Comments on SAS2r14 Physical Layer

Kevin Witt
March 21, 2008
08-144r1

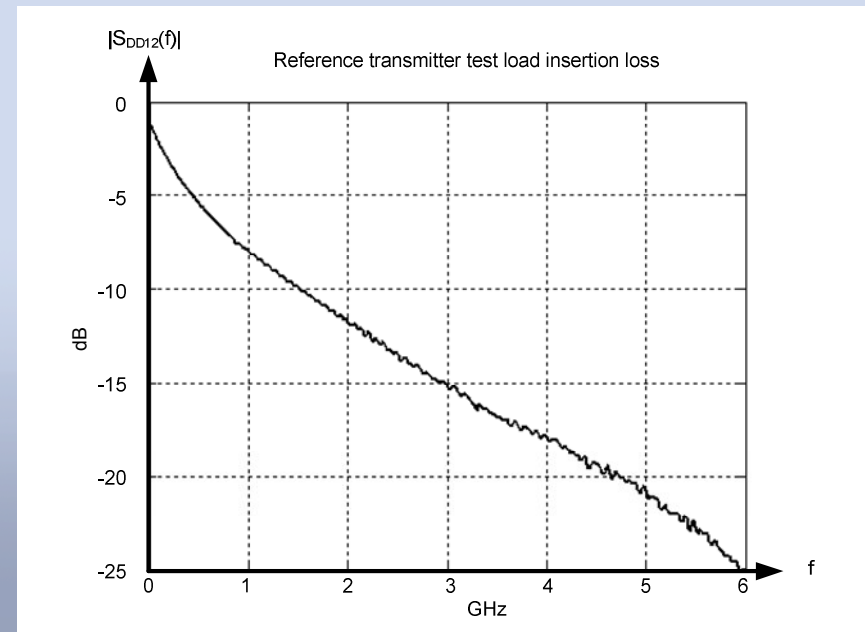
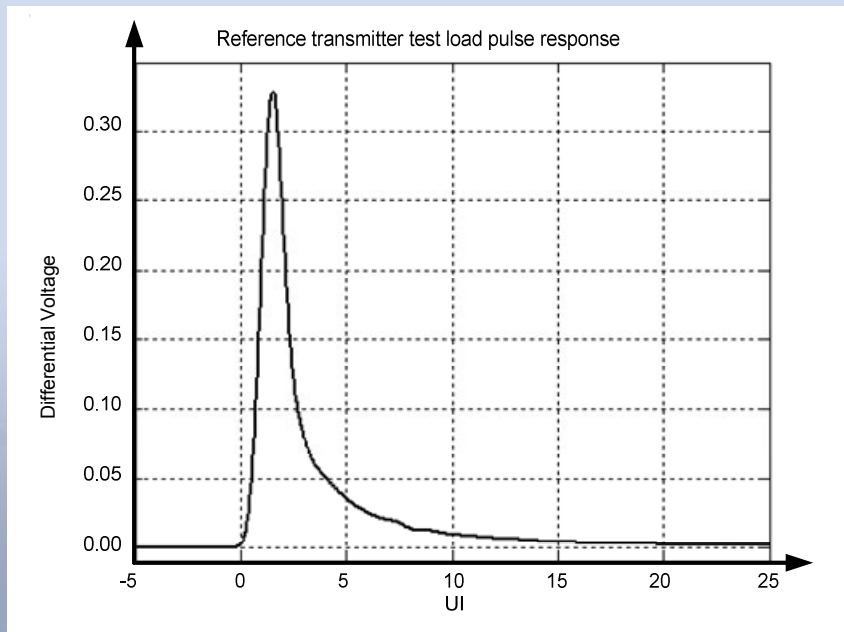
- Page 203: DFE Equation inconsistent with description.
 - Fix index of summation for $i=1$ to 3
- Page 179:
 - Add pulse response figure (Clean Ref Tx) and Insertion loss plots

— Page 205:

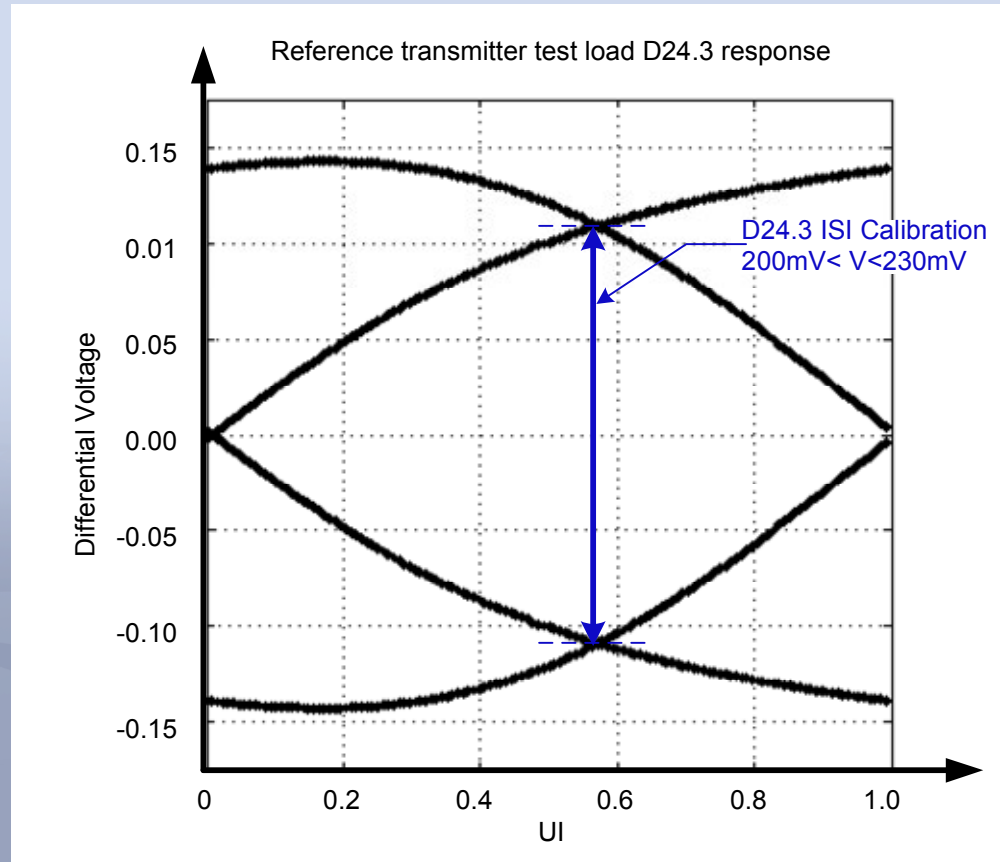
- Add D24.3 response graphic
- Change the voltage specification to
- “The difference of the “1” level centroid at the crossing, determined with a vertical histogram, minus the “0” level centroid at the crossing, also determined with a vertical histogram.

- Page Figure 127:
 - Visio Drawing,

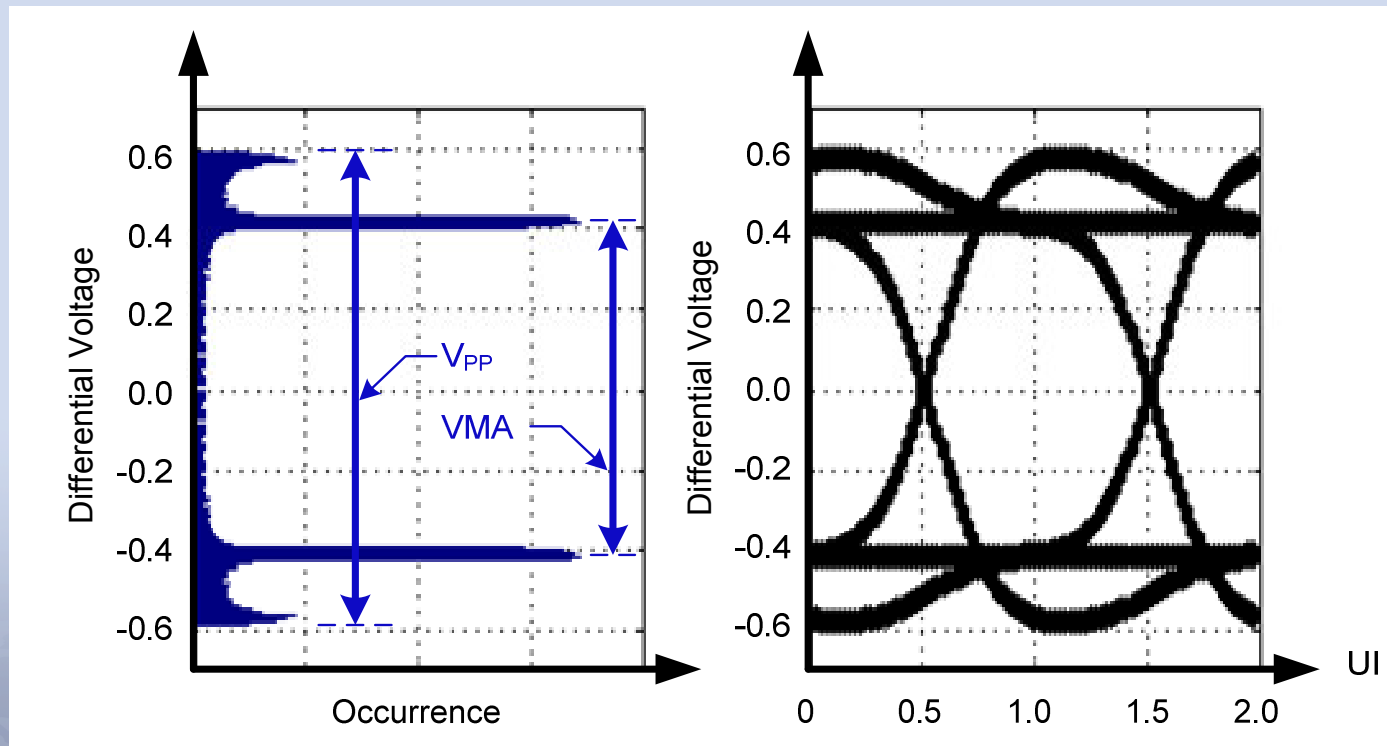
Table 65 Proposed Changes

1. Tx pk-pk 850mV
2. Change DJ to BUJ = 0.1UI
3. Remove Note b

Proposed Change to Figure 131

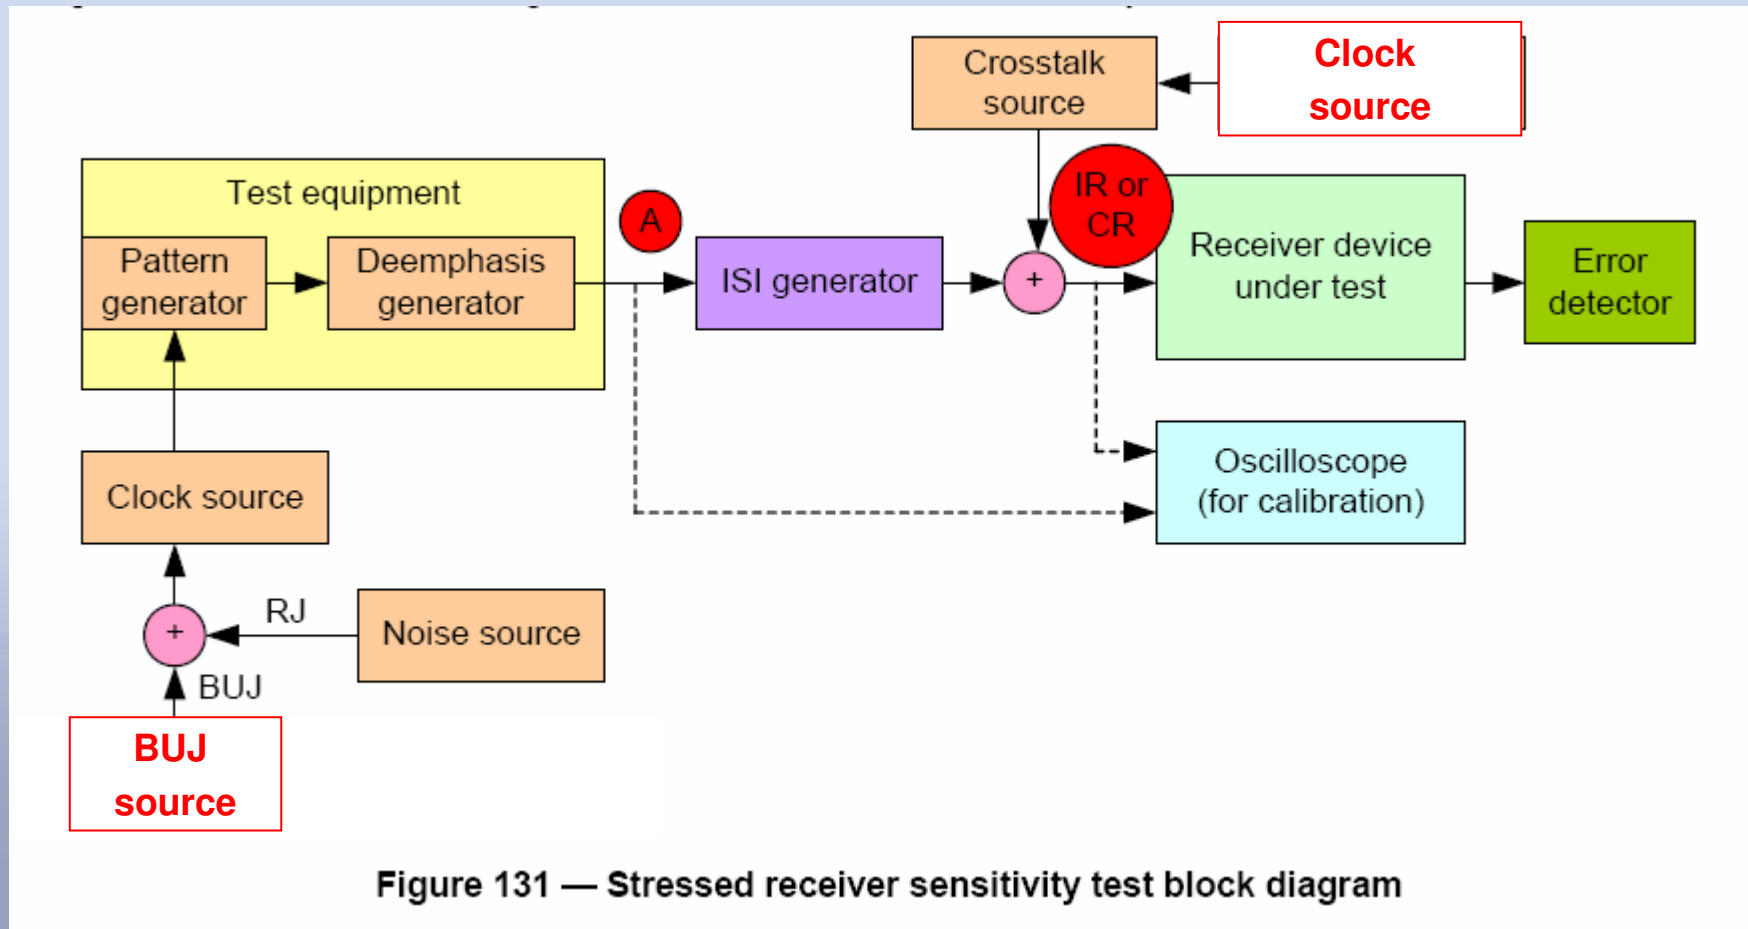
- Remove BUJ details

Figure xxx Jitter tolerance test block diagram

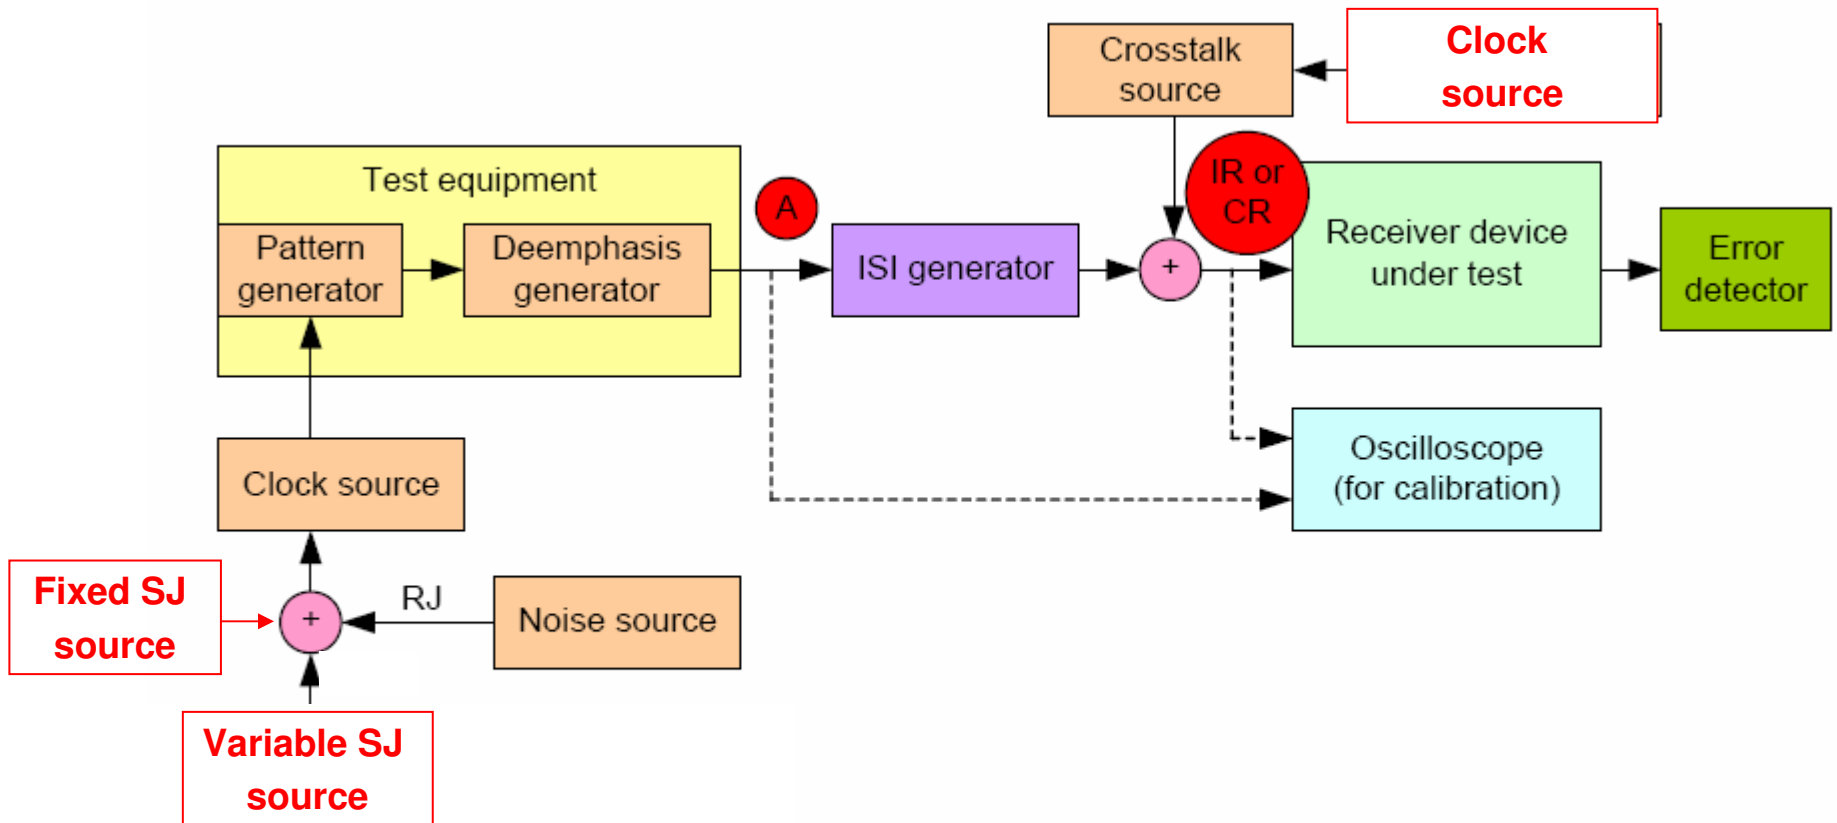
A receiver device shall satisfy the jitter tolerance test described in this subclause. The jitter tolerance test leverages the receiver device physical test hardware. The receiver device under test shall demonstrate a BER that is less than 10^{-12} with a 95 % confidence level when subjected to the sinusoidal jitter defined in 6.6.7.6. **in Figure 122 as illustrated in Figure xxx, with additional fixed SJ of 0.022UI at 20MHz.**

Proposed Change to 5.3.7.4.4.7

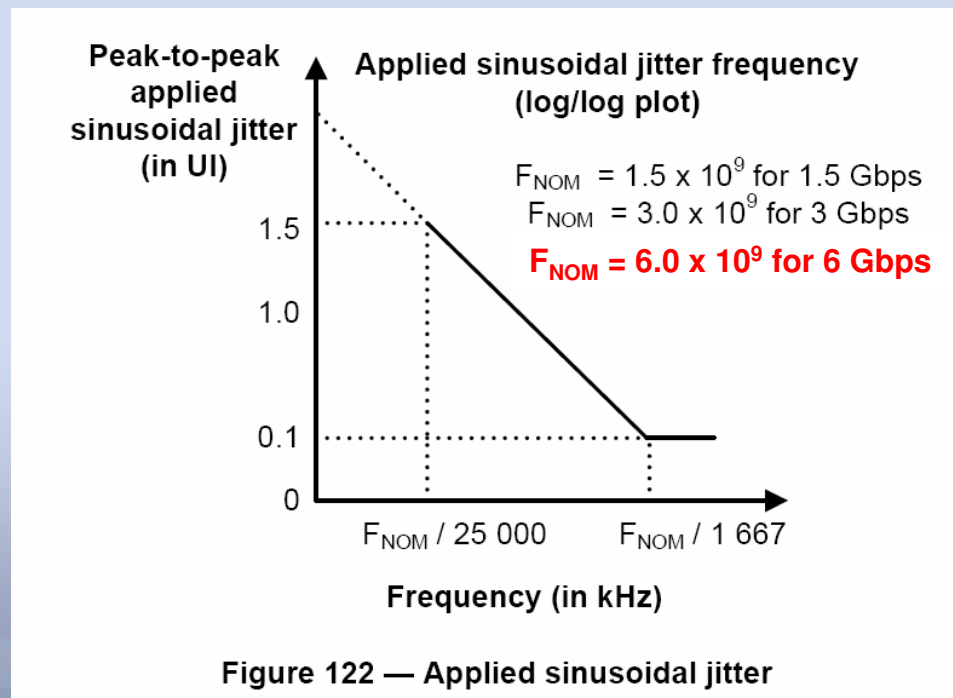
- **Figure 122 Update**

Summary of Proposed Calibration

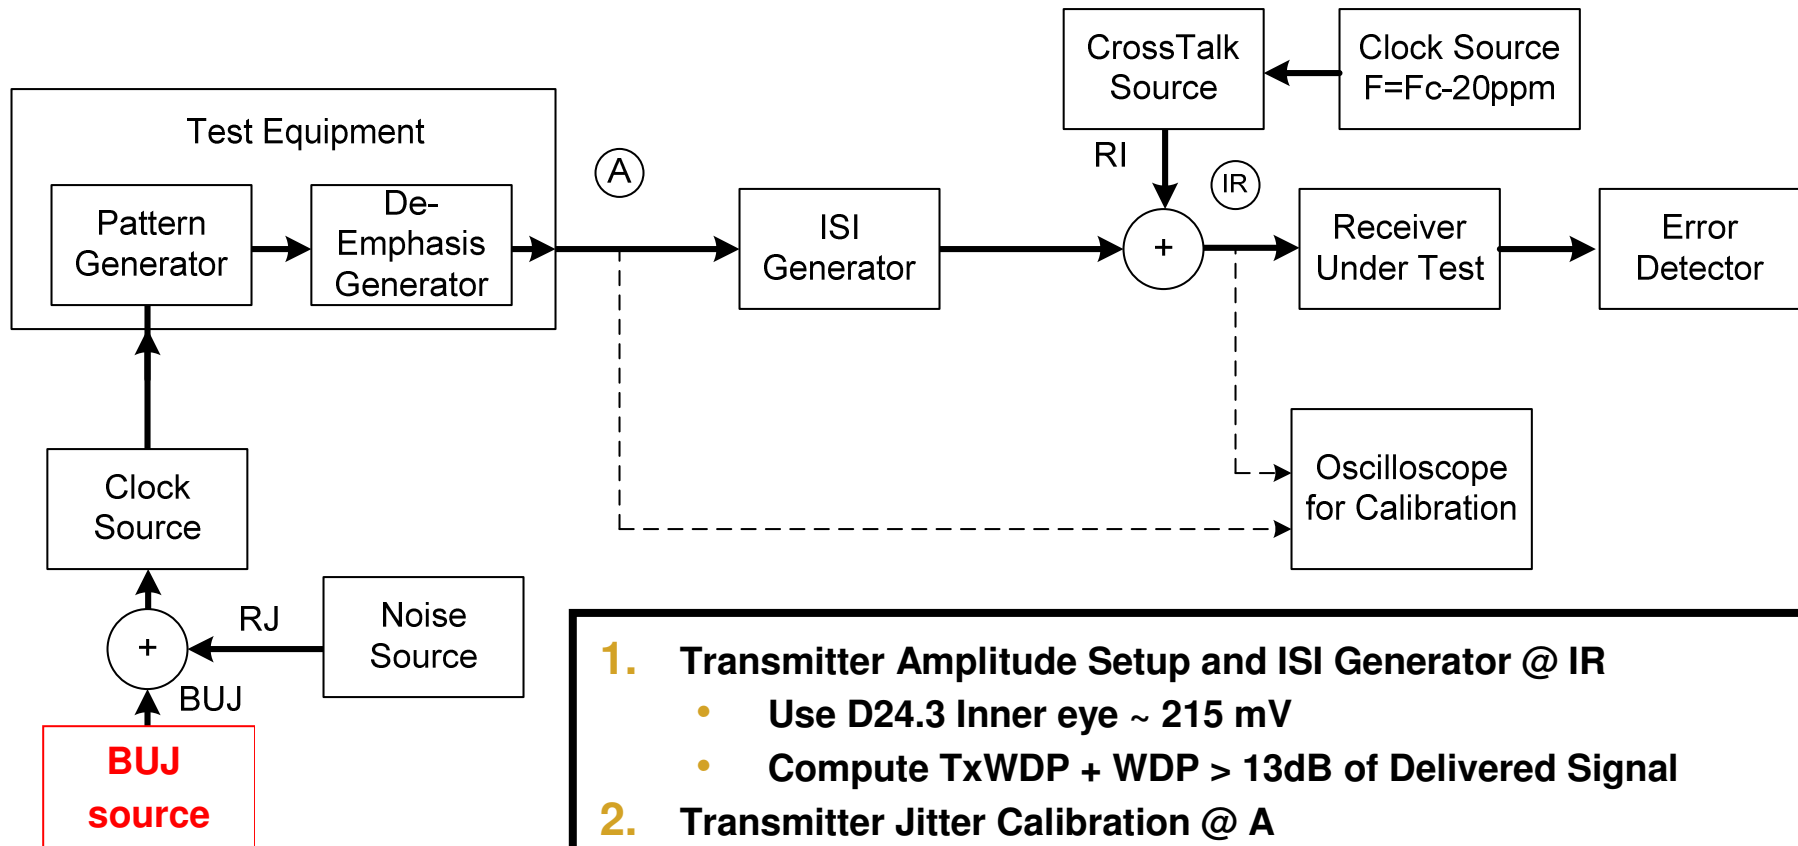
- 1. Transmitter Amplitude Setup and ISI Generator @ IR**
 - Use D24.3 Inner eye ~ 215 mV
 - Compute TxWDP + WDP > 13dB of Delivered Signal
- 2. Transmitter Jitter Calibration @ A**
 - Adjust RJ = 0.15 UI pk-pk
 - Adjust BUJ = 0.1 UI pk-pk
- 3. Crosstalk @ IR**
 - PRBS-7 Crosstalk Source and Adjust Coupled Amplitude > 4mV rms
- 4. Test – Confirm BER < 1e-12**

Calibration Procedure Illustrated

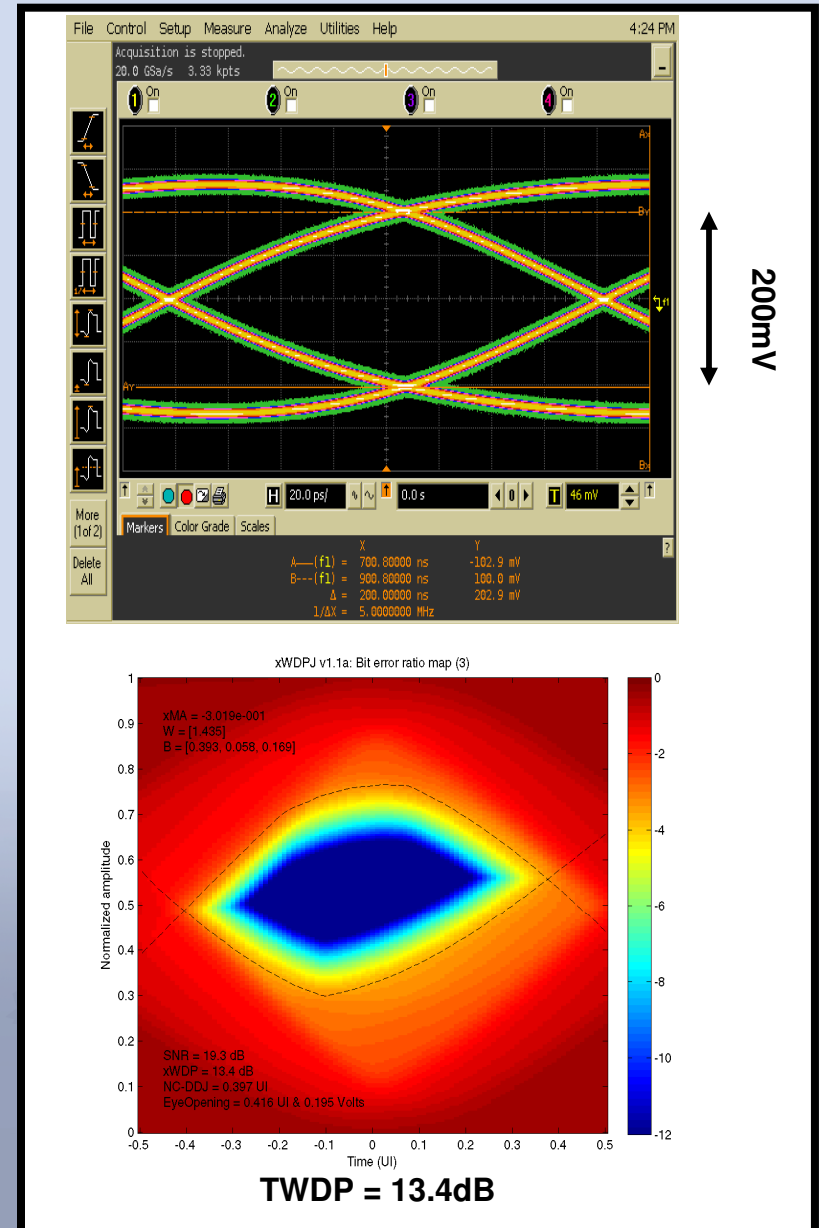
1. Measure Inner Eye with D24.3
 - Without jitter or Crosstalk
2. Compute WDP of Delivered Signal with SAS CJTPAT for the budgeted PALLOC of 15.4.
 - Make sure > 13.0 dB
3. Setup Tx Jitter with Standard Test Equipment Options.
 - $RJ = 0.15UI$
 - $BUJ = 0.1UI$
4. Setup Additional Cross talk as needed to meet NEXT limit.
 - Turn on all channels, add crosstalk for a total of 4mV RMS
5. Confirm DUT BER $< 1e-12$ @ 95% confidence
